# WHAT HAPPENED TO THE SET SCREWS?

Set screws missing from traverse bearing collar?

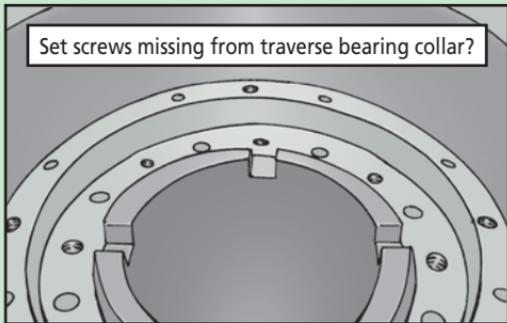
I'm a bit confused about a step in the M777A2's TM 9-1025-215-24&P. Under the *Torque the Traverse Bearing Inner and Outer Collars* maintenance instructions, Step 7 says to "remove two set screws."

Our supported unit has 19 of these howitzers, but none of them come with set screws to secure the outer collar. Am I missing something here?

Good catch, Sir. According to TACOM, a design change was introduced in Feb 08 that removed the set screws from some M777A2s. The next update to the IETM should include the following note for the traverse bearing collar maintenance instructions:

"Steps 7 and 9 through 11 detail maintenance action with regard to removal and installation of set screws (1) that are not present in all M777A2 configurations. If set screws (1) are not present, skip Step 7 and Steps 9 through 11."
